Special Called Town Commission Meeting Agenda

1. Quasi-Judicial Hearing: Appeal of the Planning & Historic Preservation Board's Approval of Micanopy Area Cooperative School (MACS) Special Use Permit.
2. Quasi-Judicial Hearing: Appeal of Planning & Historic Preservation Board (PHPB) Approval of Micanopy Area Cooperative School (MACS) Final Site Plan

To: Planning & Historic Preservation Board
From: Sara S. Samario, ICMA-CM, Town Administrator
Subject: Final Site Plan – Micanopy Area Cooperative School (MACS) Expansion
Action Requested: Approve, approve with conditions, or deny.

Ref: Construction plans for MACS Building Expansion

SHEET TITLE	DIMENSION PLAN	DATE	NOVEMBER 2025
CLIENT	MICANOPY AREA COOPERATIVE SCHOOL INC. MICANOPY, FL	PROJECT NO.	0802-24-001
PROJECT	MACS BUILDING EXPANSION	SHEET NO.	C.2.00

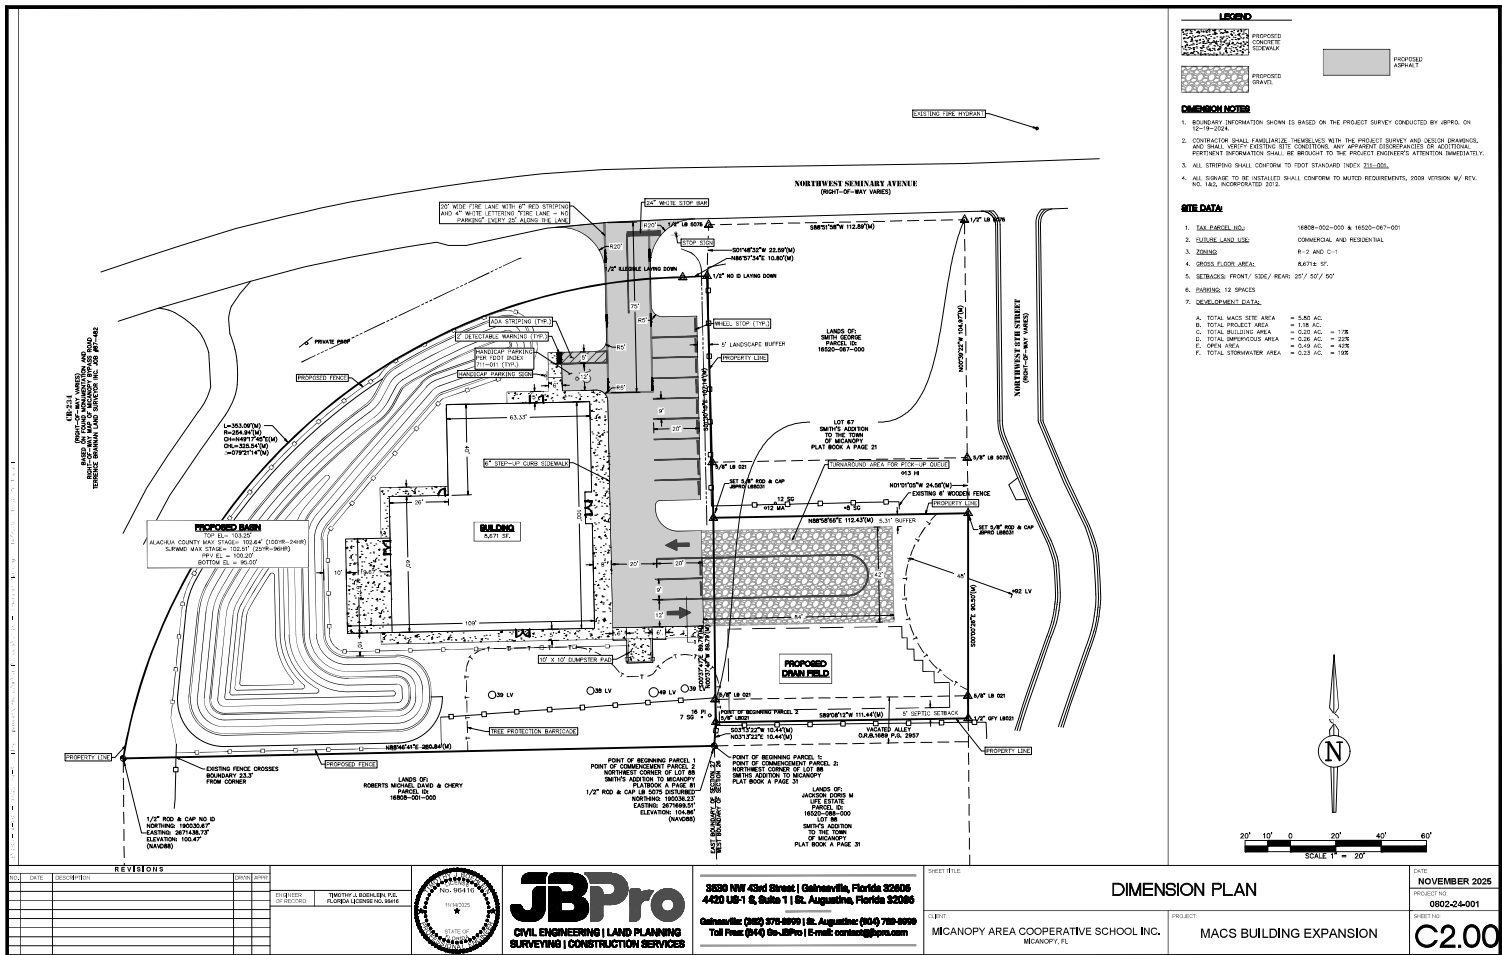
5) How can MACS increase the size of the building by 249 square feet after the preliminary site plan approval with a smaller building. This was not an approved condition in the preliminary site plan hearing. The smaller building was approved "as presented" with no further changes allowed.

6) Why doesn't the new site plan show the setbacks for the R-2 lot as required by the Code's requirements for a complete site plan application?

SHEET TITLE: **DIMENSION PLAN**

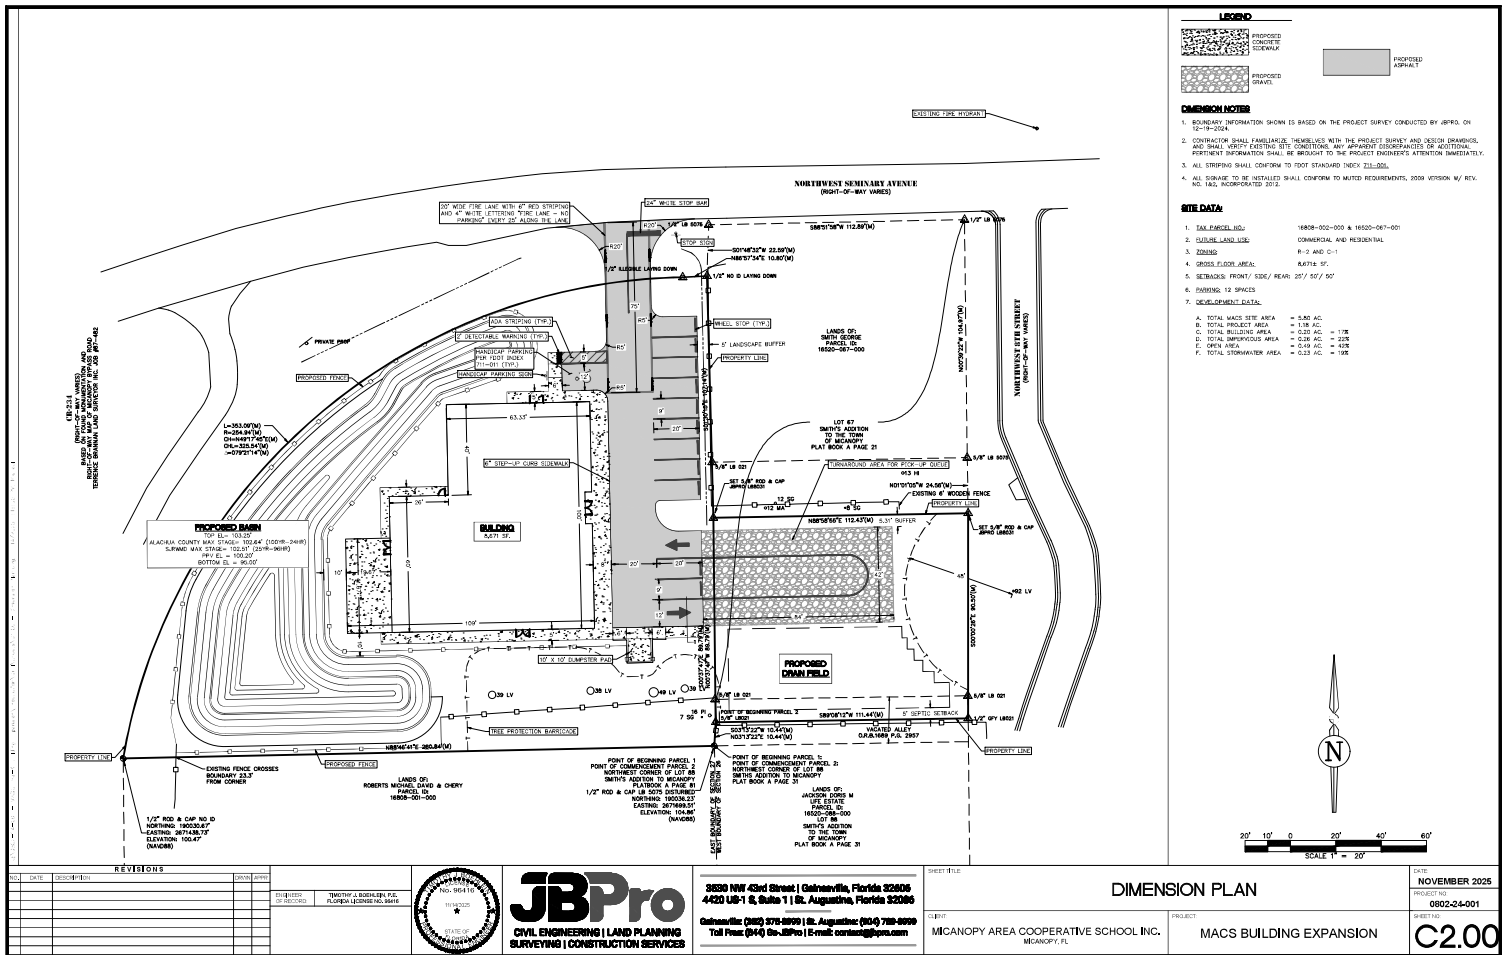
III. Tree Committee Comments (Modified Summary)

The Tree Committee reviewed the *original* site plan earlier in the process and provided **advisory comments** regarding the protection of a heritage live oak located near the proposed improvements. Their memorandum recommended a 48-foot Tree Protection Zone (TPZ) as a minimum standard.

The updated configuration satisfies the Town’s applicable tree protection standards and addresses the concerns raised in the committee’s advisory memorandum.

The Town’s engineer (EDA) has confirmed that all previous comments have been resolved, including grading, stormwater, septic, and utility revisions. The Fire Marshal has also affirmed that the proposed hydrant and water main configuration is adequate for the site.
